The Commission has issued the enclosed Amendment Nos. *62* and *57* to Facility Licenses Nos. DPR-33 and DPR-52 for the Browns Ferry Nuclear Plant, Units Nos. 1 and 2. These amendments are in response to your letter of August 13, 1980.

These amendments change the Technical Specifications to extend the exposure range of the Maximum Average Planar Linear Heat Generation Rate (MAPLHGR) versus average planar exposure from 30,000 MWd/T to 40,000 MWd/T.

SAFETY EVALUATION BY THE OFFICE OF NUCLEAR REACTOR REGULATION  
SUPPORTING AMENDMENT NO. 62 TO FACILITY OPERATING LICENSE NO. DPR-33  
AMENDMENT NO. 57 TO FACILITY OPERATING LICENSE NO. DPR-52

BROWNS FERRY NUCLEAR PLANT, UNITS NOS. 1 AND 2

MAPLHGR VS. EXPOSURE  
INITIAL CORE FUEL TYPE 2

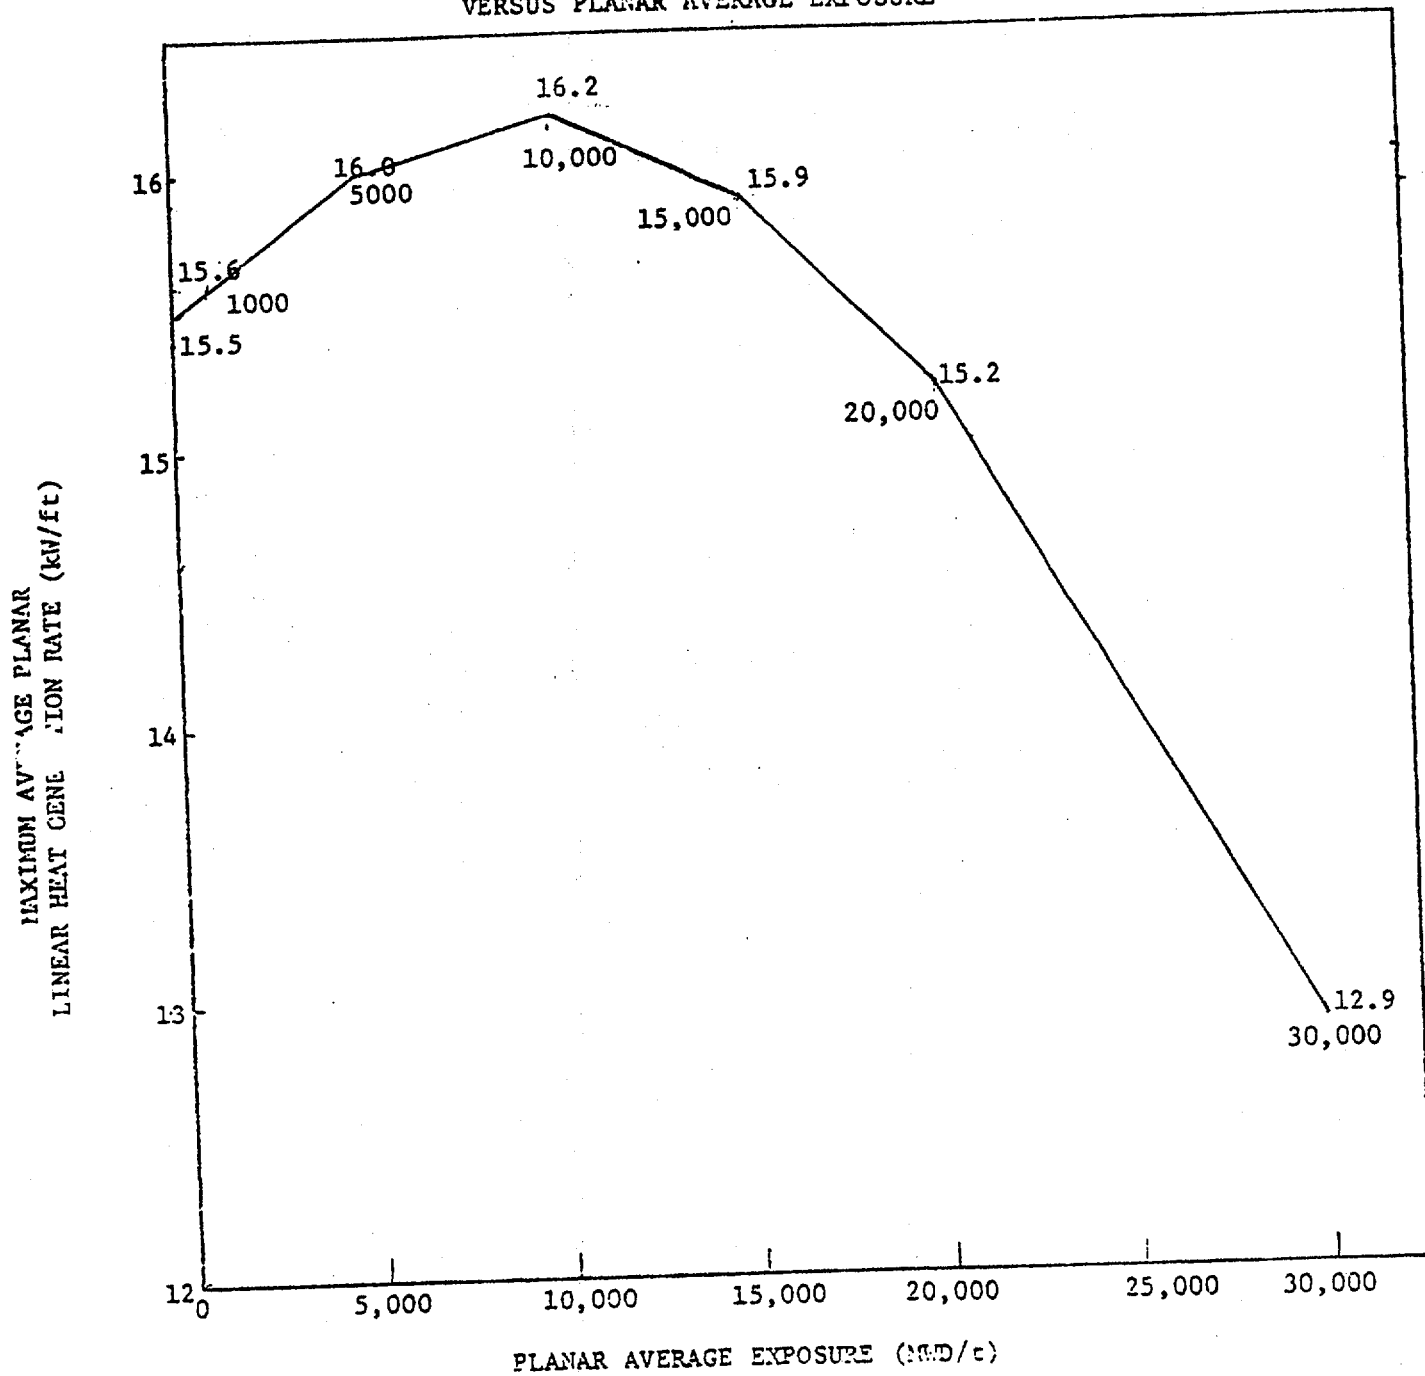
As can be noted from the attached curve (Fig. 1), the MAPLHGR limit drops off significantly beyond about 20,000 MWd/T exposure. The limits up to about 20,000 MWd/T are important because of the impact on the LOCA analyses. Beyond approximately 20,000 MWd/T exposure, the fuel does not have sufficient remaining fissionable material to have a significant effect on the LOCA calculations. The limits beyond 20,000 MWd/T are more related to fuel design (particularly cladding integrity) constraints developed by the manufacturer of the fuel. Due to depletion of fissionable material, the high exposure fuel has less nuclear capability and will operate at correspondingly lower powers, so that a wide margin is maintained between the operating LHGR and the LHGR calculated to cause 1 percent cladding dimetral strain. Basically, it is a matter for the fuel designer and manufacturer (in this case, GE) to determine - using NRC approved fuel design codes - whether the mechanical design of his fuel is adequate. Originally, GE has set 30,000 MWd/T as a limit from the standpoint of fuel warranty, not as a safety limit. In discussing the safety evaluation of the fuel mechanical design, the Browns Ferry Final Safety Analysis Report (FSAR) discusses and lists LHGR limits up to 40,000 MWd/T for both 7x7 and 8x8 fuel (Section 3.2.5, p. 3.2-6). Similarly, in discussing the thermal and hydraulic design of the fuel, the FSAR discusses the LHGR rates for both 7x7 and 8x8 fuel assemblies up to 40,000 MWd/T (Section 3.7.4, p. 3.7-2). Thus, it is evident that at least LHGR rates up to 40,000 MWd/T exposure were evaluated in the initial design of Browns Ferry.
